CITY OF NAPOLEON - BUILDING DEPARTMENT

Additional Information: Unattached garage.

RESIDENTIAL PLAN CORRECTION SHEET

ADDENDUM TO Permit No. 01378 m(1)
Owner FLOOR CARES
Contractor SELF
Location 1172 WILCARD

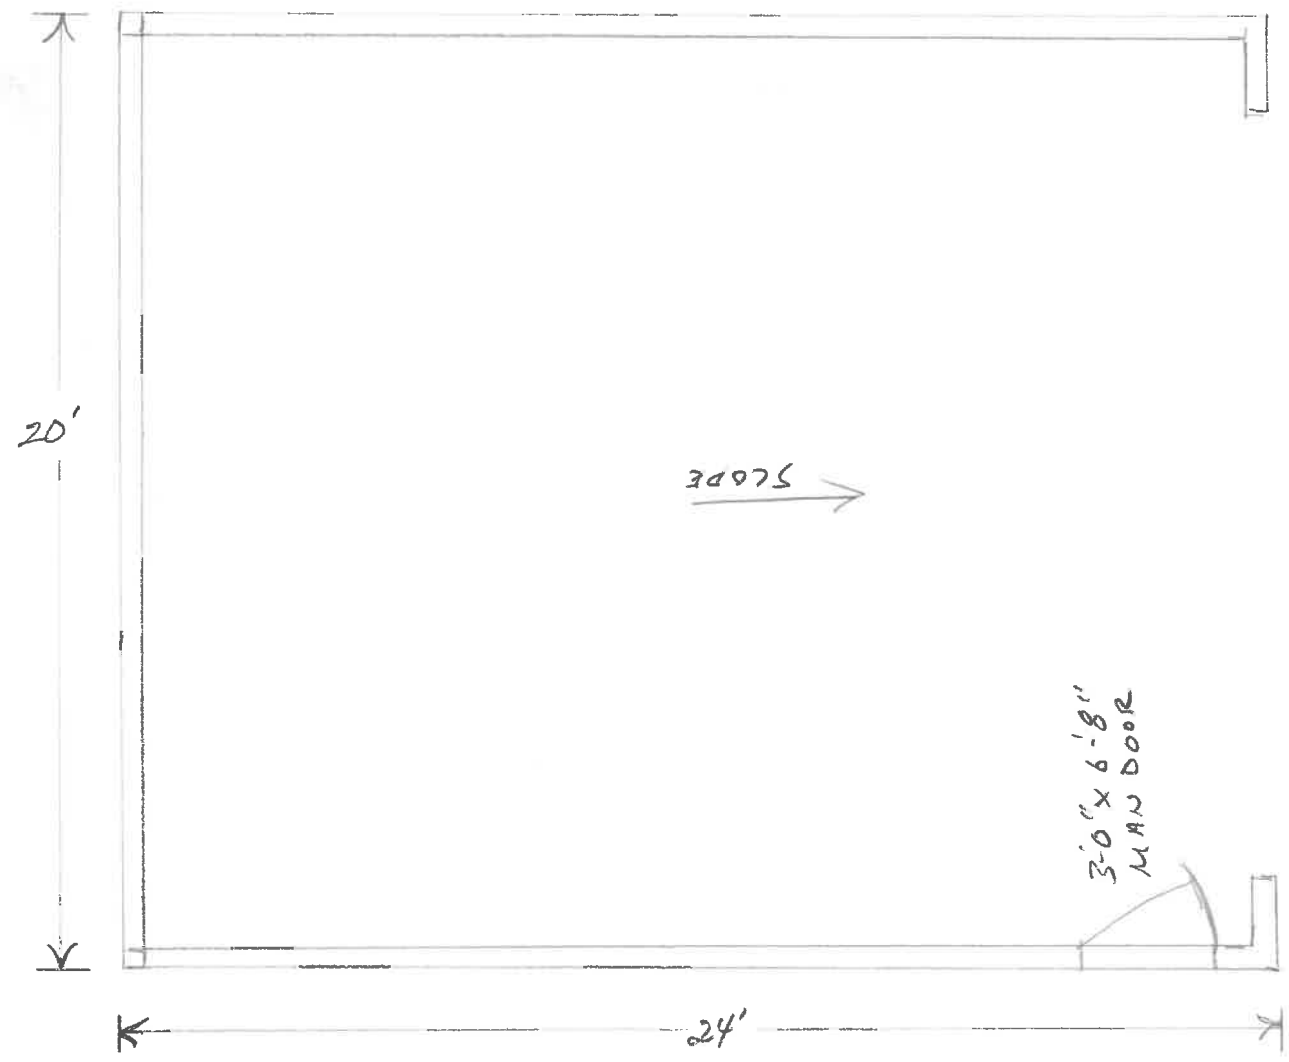
Additional Corrections. PROVIDE A 3'-0" X 3'-0" STOOP ON THE EXTERIOR SIDE OF THE WAO DOOR

The following orders are hereby issued for their correction: I ORDER THAT YOU MAKE
DO NOT GET INTRUCK DURING CONG STOOD AT THE
EXTERIOR SIDE OF YOUR BARRAGE MAN DOOR.
PLEASE CALL ME WHEN YOU HAVE THE DOOR SO THAT
I CAN TURN OUT THE TRUCK.
